TOWN OF HOLLISTON IT DEPARTMENT

ADDENDUM #1 MUNICIPAL FIBER PROJECT - HOLLISTON

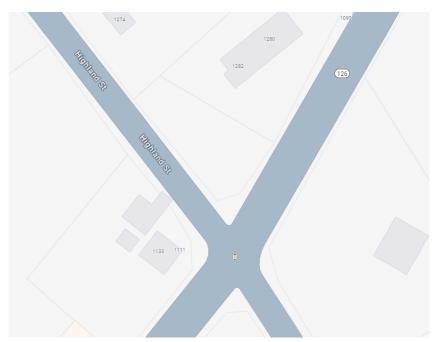
1. Are any of the building terminations located more than 50 feet from the building entrance and not routed through conduit? That is an exposed cable.

Answer: Yes two of the buildings the final termination location will be more than 50' from the wire entrance.

- 1750 Washington Street is located about 75' from the entrance with drop ceilings.
- The High School is located about 150' from the entrance of the wire. At the High School, there is conduit from the street into the Holliston Cable Studio entrance (center right of the front of the building). From this entrance the final termination is about 150' through 4 brick walls and drop ceilings (at least 2 walls already have drill holes for running cable. The other two walls may need to be drilled.)
